Technical Bulletin
No: 127 – Instructions for Modifying console meter strap
from Hoyt to Modutec Meters

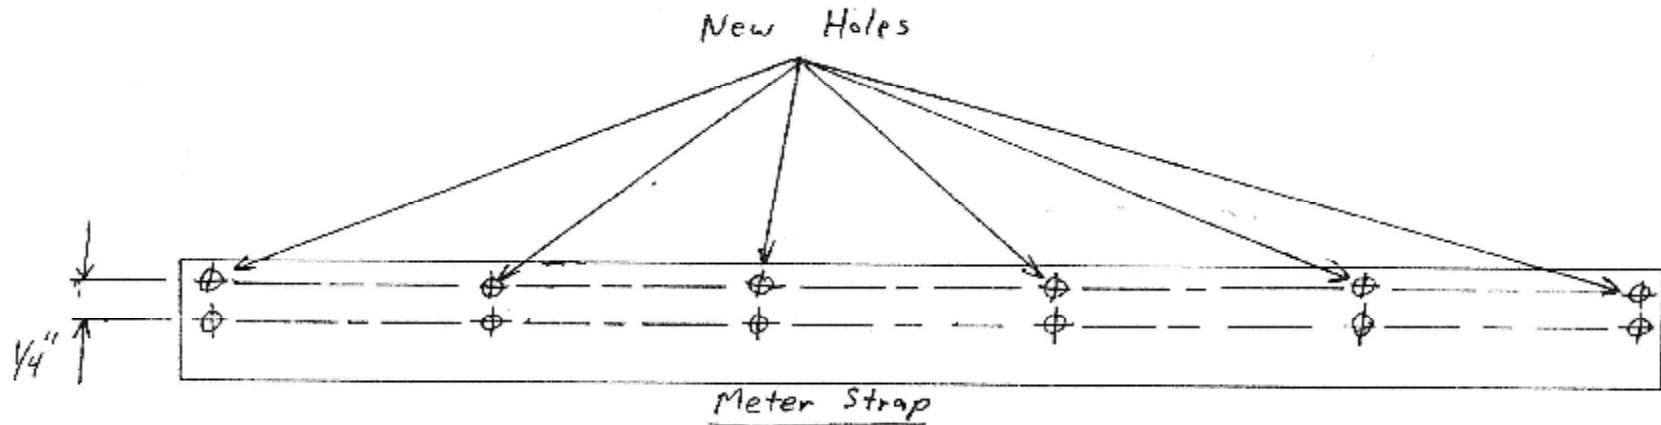
To modify RS console Hoyt meter strap for Modutec meters
drill a new $\frac{5}{32}$ " hole $\frac{1}{4}$ " above the center of all existing holes
